S E R V I C E N O T E

Agilent E5000A PRML Bit Error Analyzer

Serial Numbers: JP1KC00101 / JP1KC00178

DATE: September 2000

Figure 1. AC Line Connector

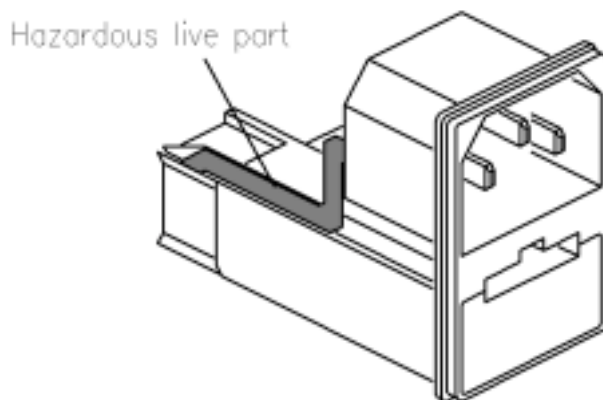
The AC inlet (P/N 1252-6951) has the potential to slip out of the instrument's rear panel slot if the AC power cord is forcefully pulled in a diagonal direction. When this happens, an exposed connection on the AC inlet module may touch the rear panel of the instrument and cause an electrical short if the AC power cord is still connected to the AC power outlet. See Figure 1.

In the worst case, there is also a possibility of an electric shock hazard to the user if the user completes a circuit between the instrument panel and another grounded connection while the AC power cord is still connected to the AC power outlet.

- Remove the AC power cable from the AC power outlet and the product.
- Remove the top, bottom, and side covers.
- Seal the hot line terminal on the AC inlet with silicon paste (P/N 5183-4112).
- Reinforce the connection between the AC inlet and the rear panel with silicon paste.
- Perform Self Test to verify instrument operation.

- Remove the AC power cable from the AC power outlet and the product.
- Remove the top, bottom, and side covers.
- Seal the hot line terminal on the new AC inlet with silicon paste (P/N 5183-4112).
- Replace the AC Inlet (P/N 1252-6951)
- Reinforce the connection between the AC inlet and the rear panel with silicon paste.
- Perform Self Test to verify instrument operation.
